STAFF RECOMMENDATION

920 Lawrence Ave

August 21, 2019

Application: New construction – Addition and Detached Accessory Dwelling Unit;
Partial Demolition

Figure 2 (left) the garage that is to be demolished. Figure 3 (right) is the 1951 Sanborn map, possibly showing the existing garage that is to be demolished.

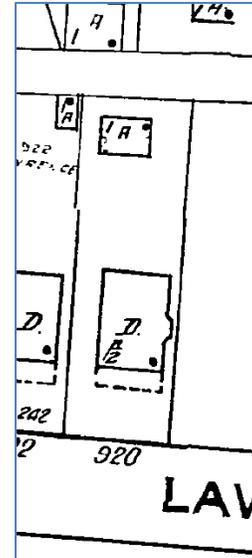
Partial Demolition: The project involves the demolition of an existing outbuilding as well as partial demolition of portions of the house. The date of construction of the existing garage is not known (Figure 2). It is possible that it is the same structure that appears on the 1951 Sanborn Map. While the stone outbuilding is older, staff finds that it does not contribute to the historic character of the house or the conservation zoning overlay. It is not a high-style outbuilding, does not relate to the architecture of the historic house, and cannot be easily adapted for modern garage and apartment use. In the past, the Commission has not required the retention of outbuildings, even when they are more than fifty years old, as they typically do not relate directly to the historic character of the house, are not highly visible to the street, and their removal does directly impact the historic character of the house or neighborhood. Staff therefore finds that the demolition of the outbuilding meets the design guidelines.

Figure 5 (left) shows in red the windows that are to be removed. Figure 6 (right) shows the windows that are to be added.

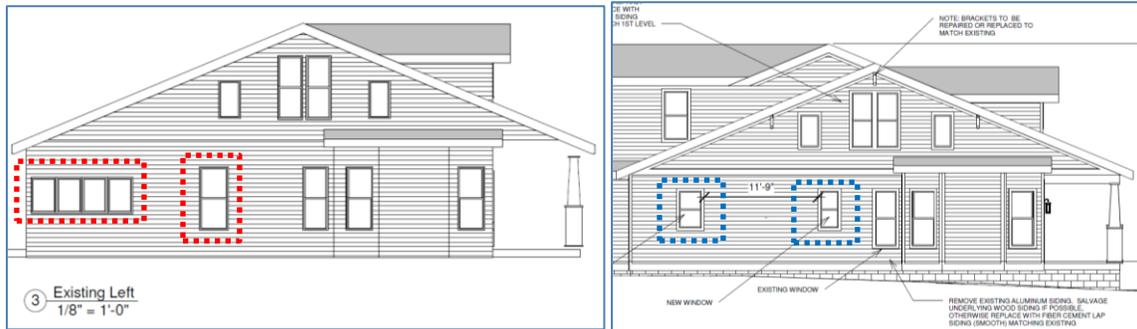
The applicant also intends to alter some window openings on the side facades, which is considered partial demolition. All of the window alterations are in the back half of the house, behind existing, historic bays. Because of their location behind the bays, they are not highly visible from the street. On the left façade, one larger double hung window will be replaced with a small, vertically-oriented window, and a band of four windows will be replaced with one, smaller, vertically oriented window (Figure 5 & 6). On the right

Figure 7 (left) is a photo of the right side of the house, where the proposed window change cannot be seen because it is behind the bay. Figure 8 (right) indicates the dimensions of the new window opening.

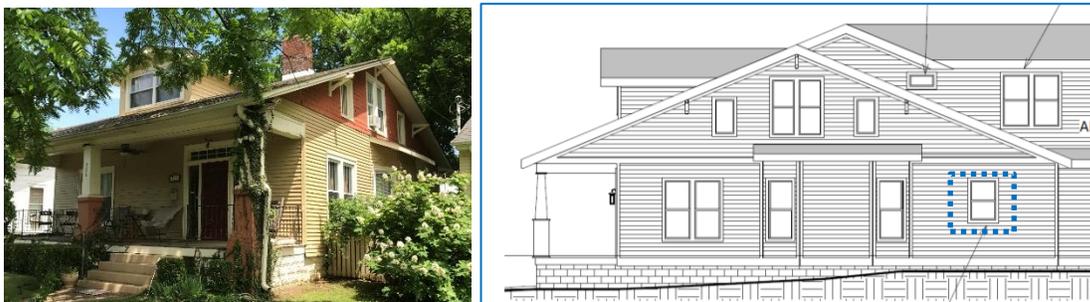
façade, an existing double hung window opening will be reduced in size (Figures 7 & 8). Staff finds that these window changes are appropriate because they are located towards the back of the house, behind bays; they will not be highly visible from the street.

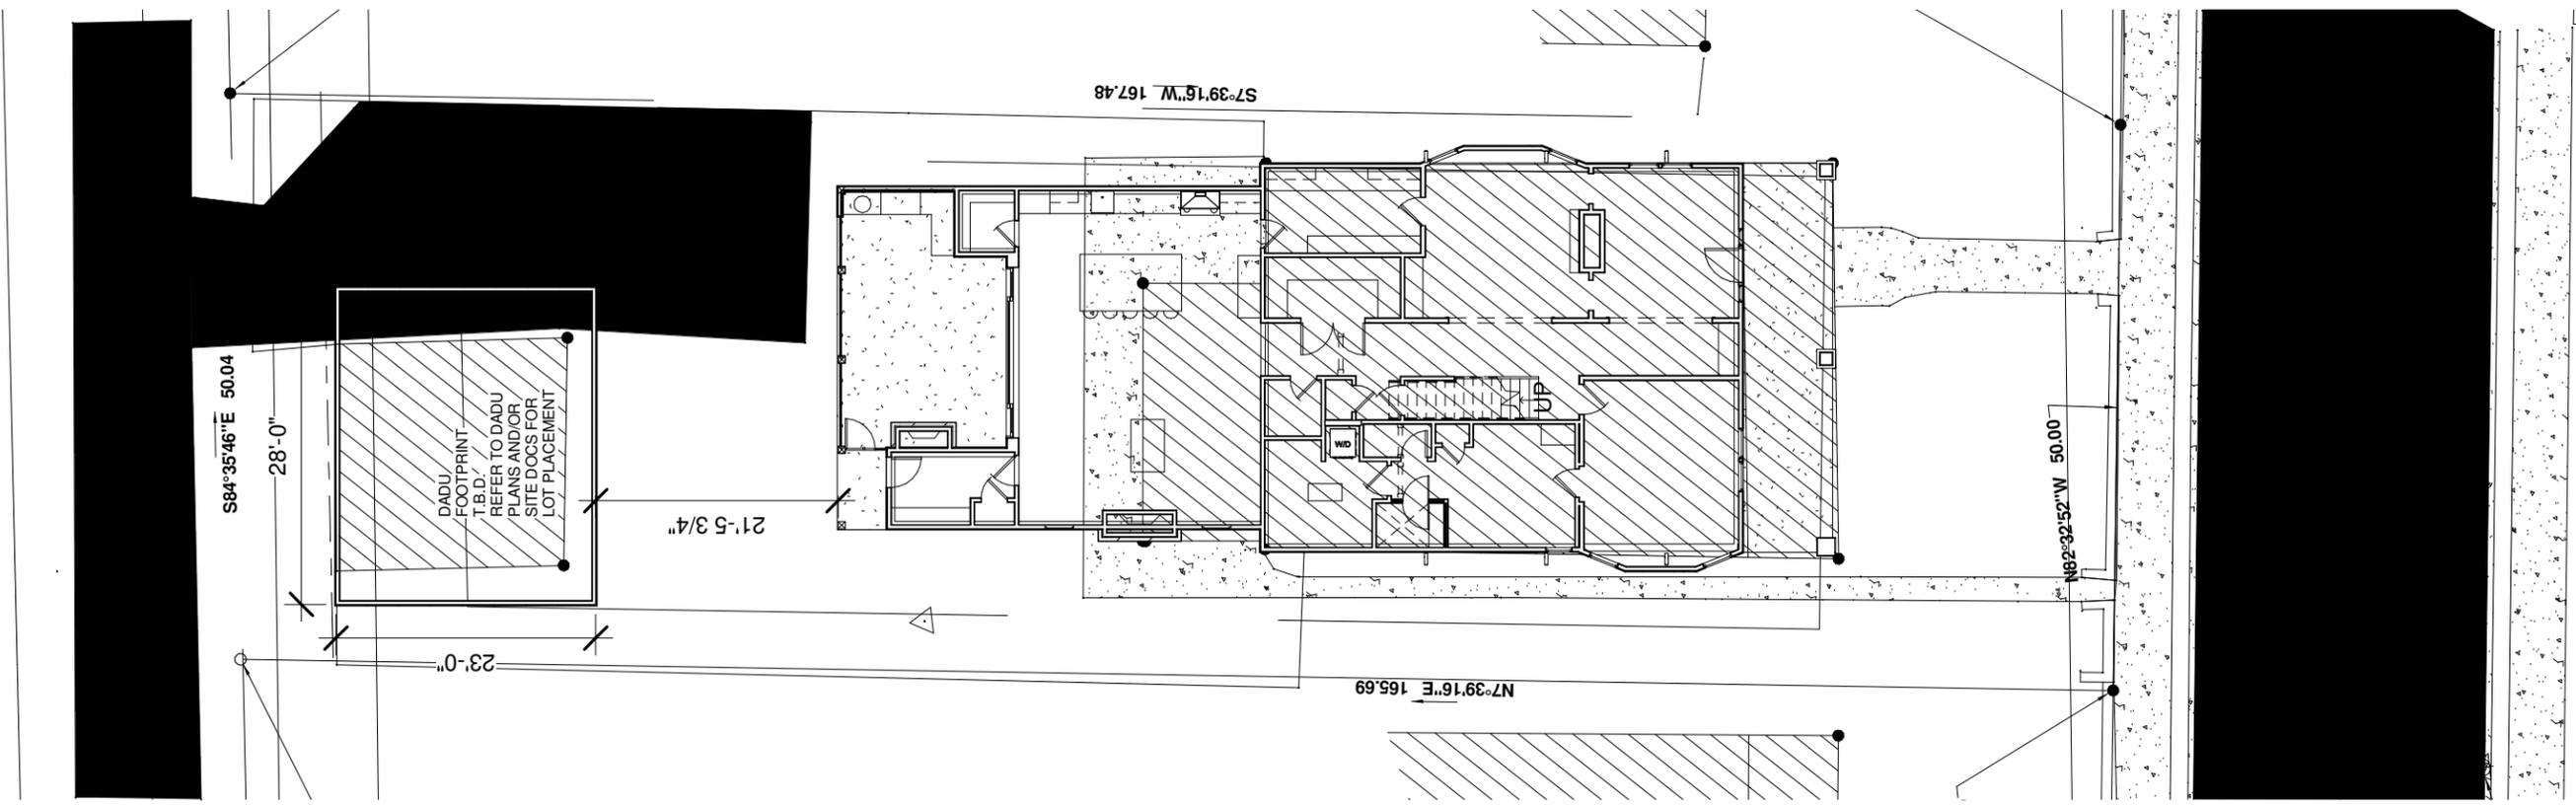
The ridge height brings the ridge height of the historic house to twenty-three feet, six inches (23'6). The measurement is taken from the floor line. The lot slopes slightly up from the front towards the back. The Commission typically takes the measurement from the finished floor line/foundation line to ensure that slope does not skew the overall height of the house. At the point of the ridge, the house's floor line is close to the grade. The applicant is proposing that the DADU be one foot taller than the historic house, with the ridge raise. The design guidelines states, "The roof ridge line of the detached accessory dwelling must be less than the primary structure and shall not exceed twenty-five feet in height." Staff finds that the DADU should be reduced by approximately one foot (1') in order to meet the design guidelines and the DADU ordinance.

With the conditions that ridge height of the DADU be reduced to be no taller than 23'6", and that staff approve all materials, staff finds that the DADU meets Section III.H of the design guidelines for outbuildings and the DADU ordinance, Section 17.16.030.G.

Site - Proposed		H5
Date	7/29/19	
Drawn by	J. Feller	Scale 1/16" = 1'-0"

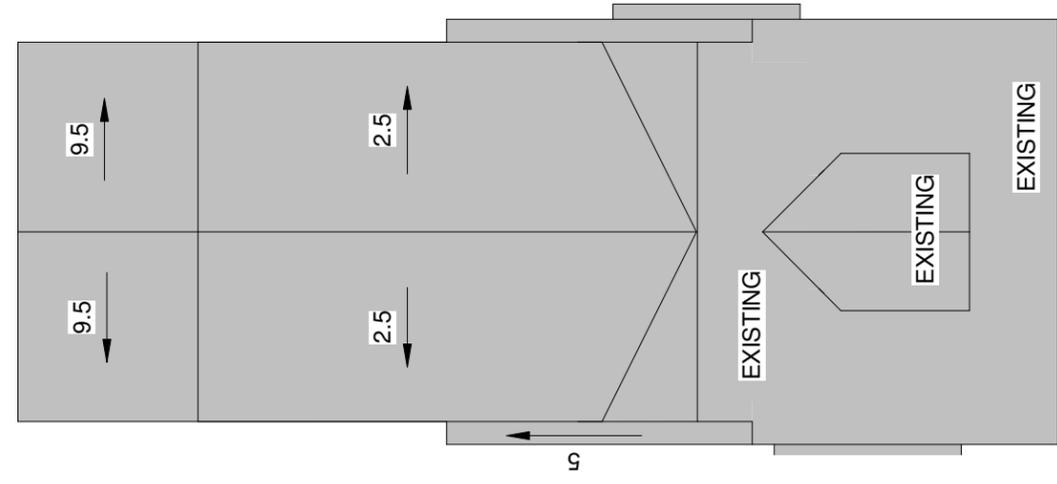
Appurtenances & Utilities: The site plan does not indicate the location of the HVAC and other utilities. Staff recommends that the HVAC be located on the rear façade, or on a side façade beyond the midpoint of the house.

Outbuilding: The new DADU is a twenty-three feet by thirty-two feet (23’X 32’), or seven hundred and thirty-six square feet (736 sq. ft.). The site plan indicates that the outbuilding is twenty-three feet by twenty-eight feet (23’X 28’), so staff recommends that a condition of approval be that a corrected site plan be provided.

1. The rebuilt front porch columns match the historic columns in materials, configuration, and details;
2. Staff approve the final details, dimensions and materials of windows and doors prior to purchase and installation;
3. Staff approve a brick sample;
4. Staff approve the roof shingle color and texture;
5. The site plan be updated to show the correct footprint of the DADU;
6. The DADU be reduced in height to be no taller than twenty-three feet, six inches (23'6"); and
7. The HVAC be located behind the house or on either side, beyond the mid-point of the house.
